**PSE&G** Public Service  
Electric and Gas  
Company

August 20, 1984

HOPE CREEK GENERATING STATION  
DOCKET NO. 50-354  
DRAFT SAFETY EVALUATION REPORT  
OPEN ITEM STATUS

Attachment 1 is a current list which provides a status of the open items identified in Section 1.7 of the Draft Safety Evaluation Report (SER). Items identified as "complete" are those for which PSE&G has provided responses and no confirmation of status has been received from the staff. We will consider these items closed unless notified otherwise. In order to permit timely resolution of items identified as "complete" which may not be resolved to the staff's satisfaction, please provide a specific description of the issue which remains to be resolved.

FIGURE 220.21-17

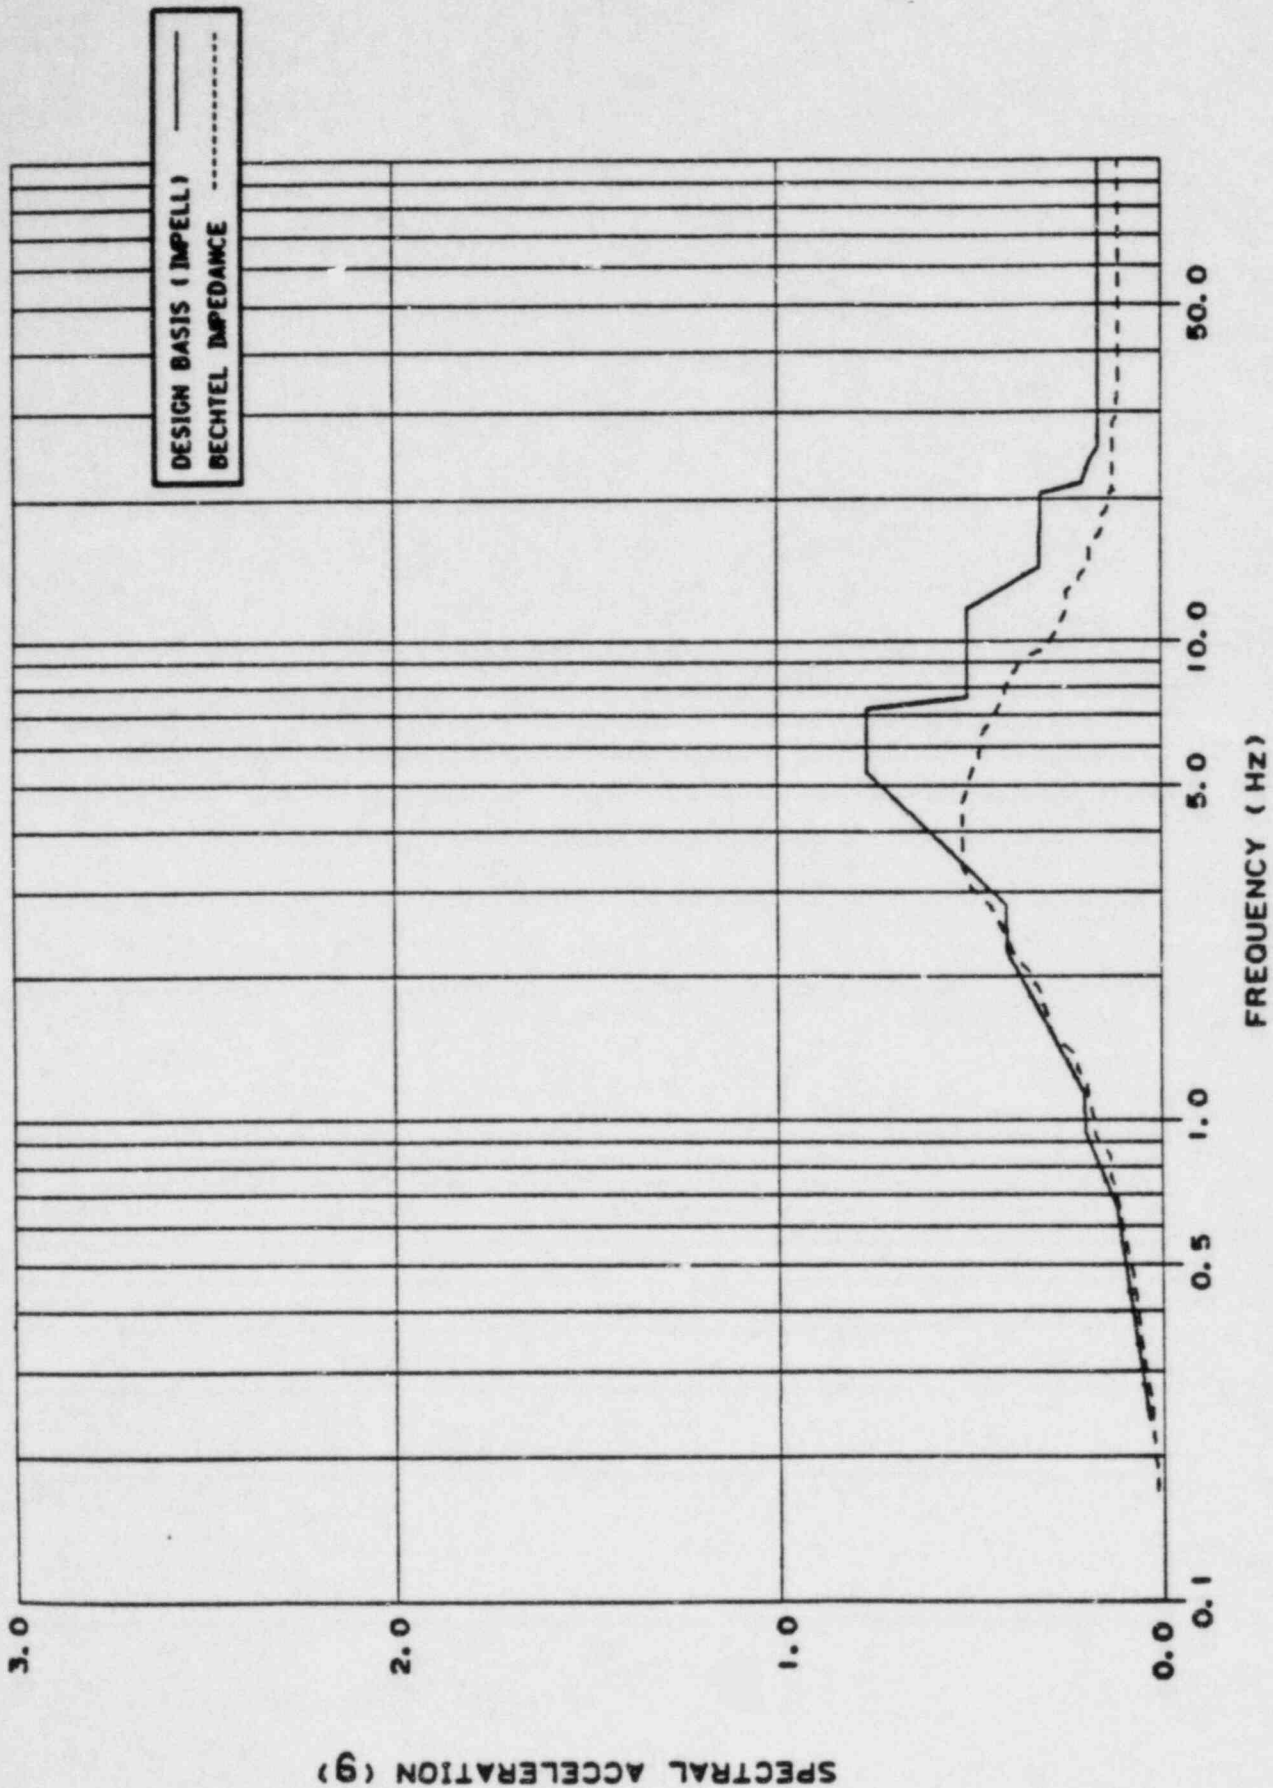
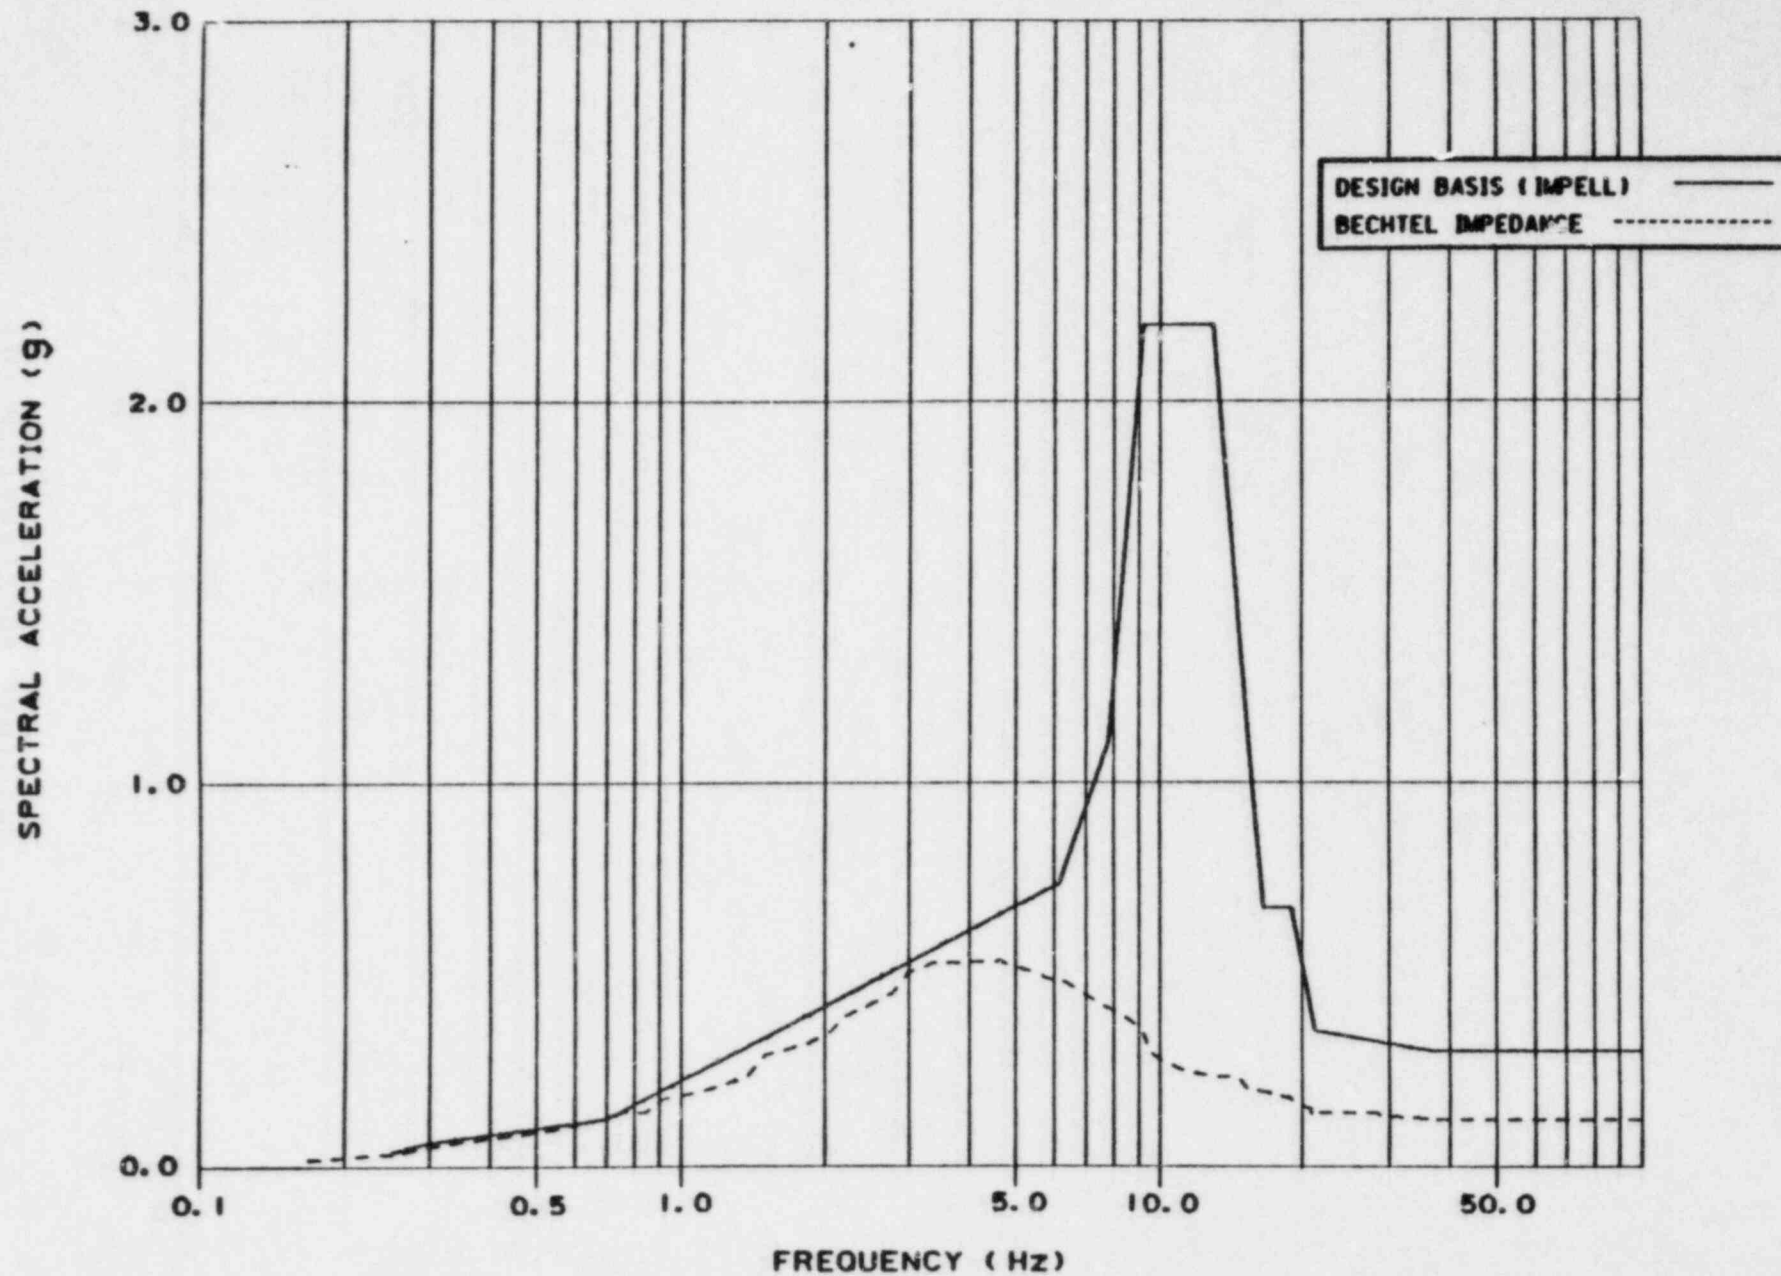
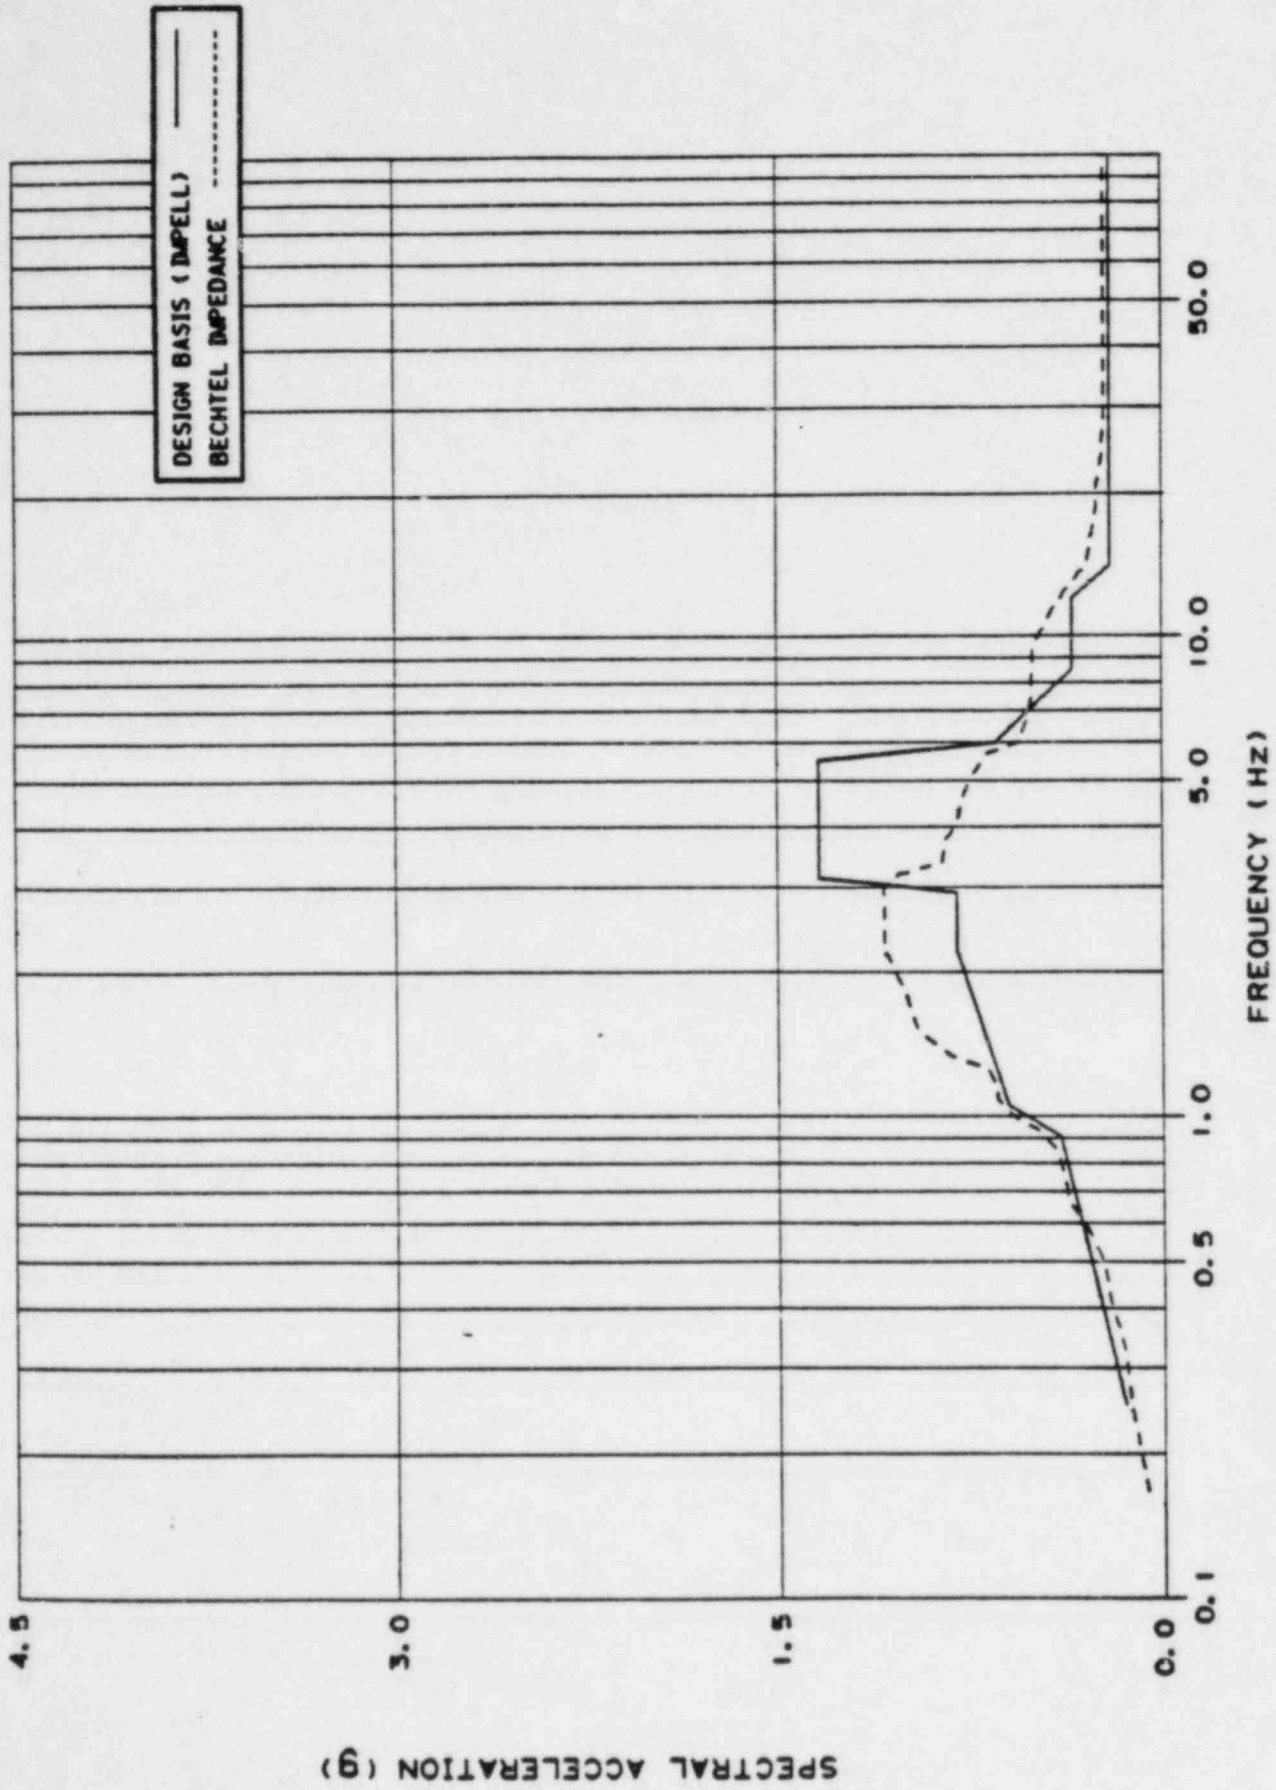
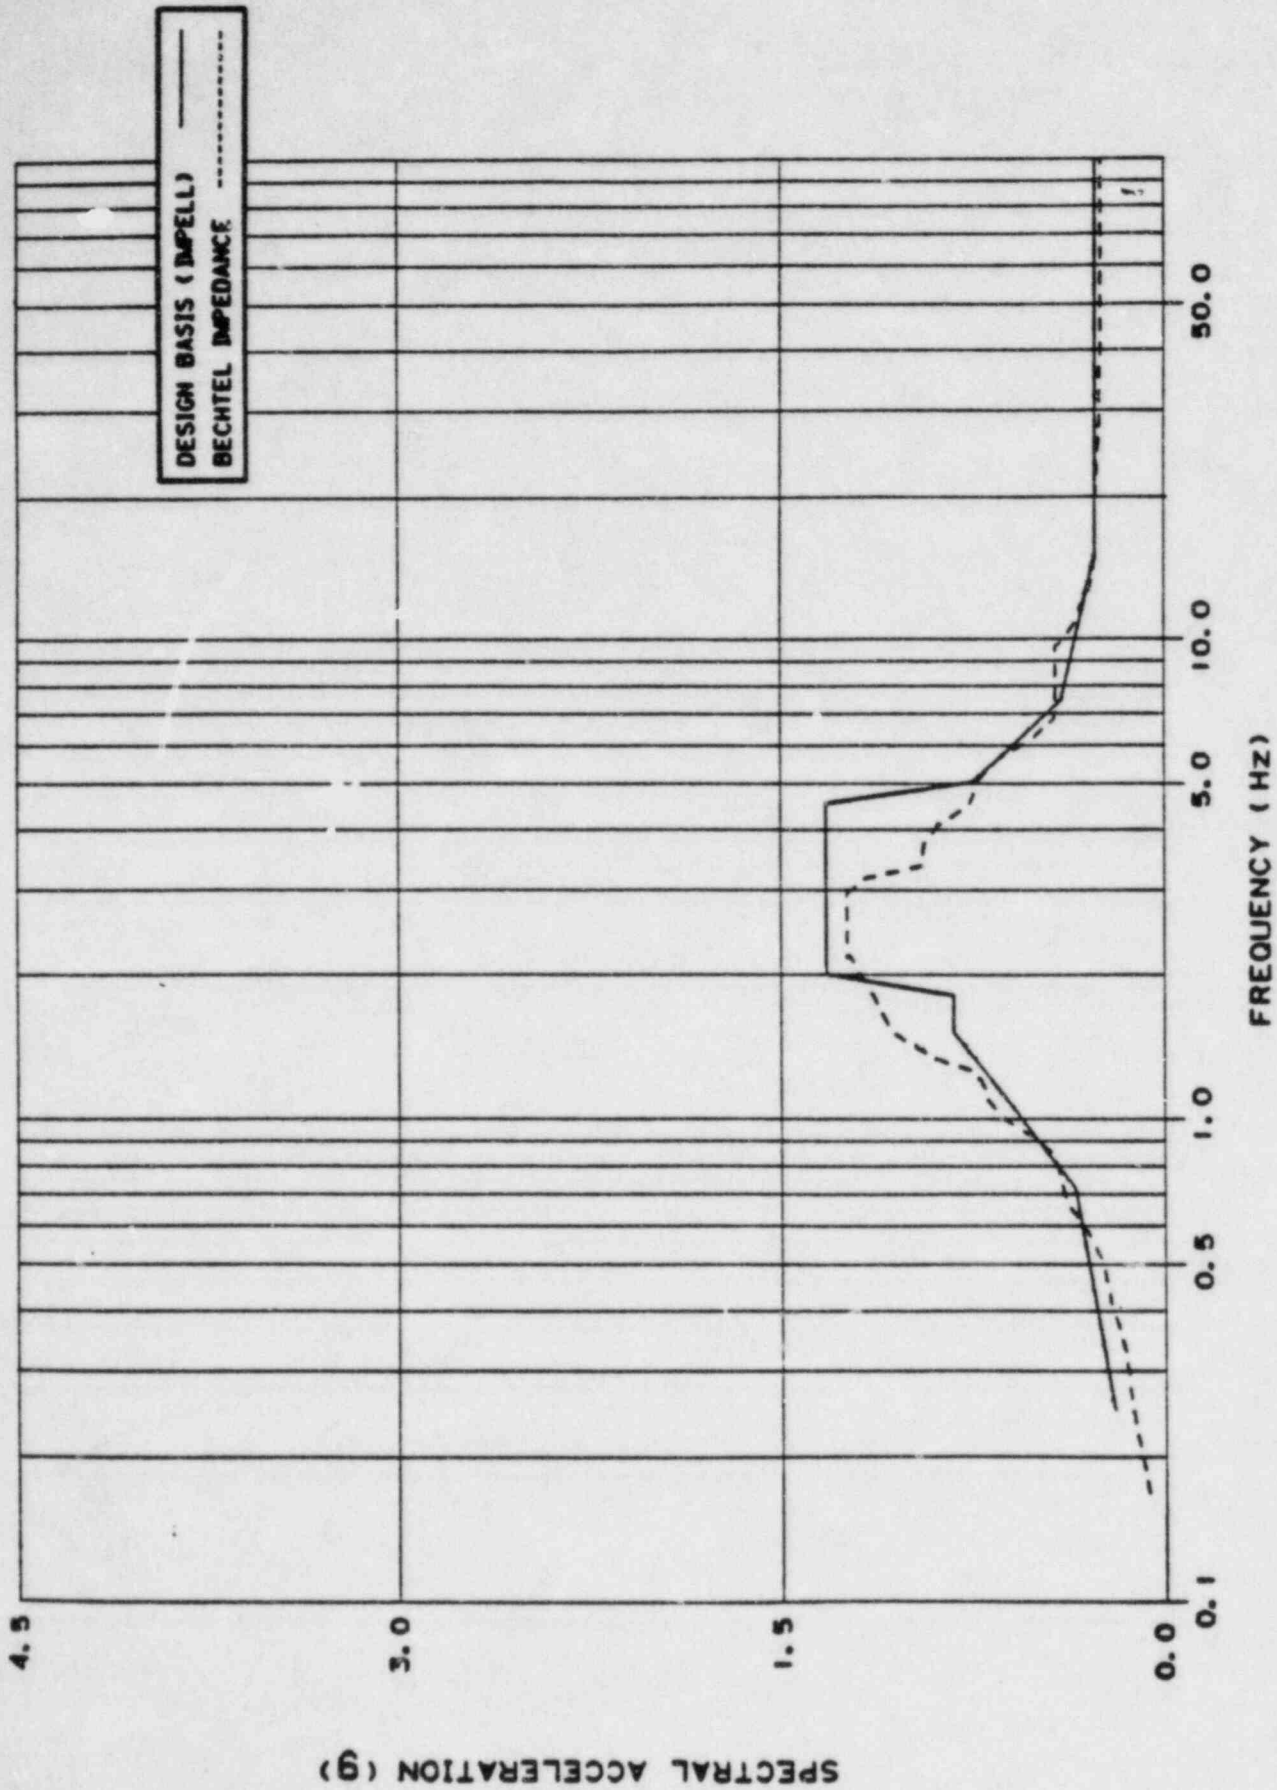
Figures 220.21-1 through 220.21-54 show a comparison of the 2 percent damping response spectra obtained from the design basis finite element and the impedance analyses for the reactor building, auxiliary building and the service water intake structure (SWIS).

¶ For the reactor and auxiliary buildings, the peak spectral accelerations obtained from the impedance analysis are generally lower than those obtained from the design basis analysis. However, the impedance analysis response spectra are not completely enveloped by those obtained from the design basis analysis, especially in the frequency range from 1.0 to 3.5 Hz. Also, there are some local exceedances in the higher frequency range, as shown in Figures 220.21-1 through 220.21-36. ¶ For the SWIS (Figures 220.21-37 through 220.21-54), the impedance analysis response spectra are generally enveloped by those obtained from the design basis analysis at elevation 114.0 feet. For other elevations, the impedance analysis spectral accelerations exceed the design basis spectral accelerations in some frequency ranges. These ranges vary approximately between 1.5 and 10.0 Hz.

In all cases, the items reviewed during these sampling studies can accommodate the loads resulting from the impedance analysis. Therefore, the impedance analysis results have no impact on the plant design.
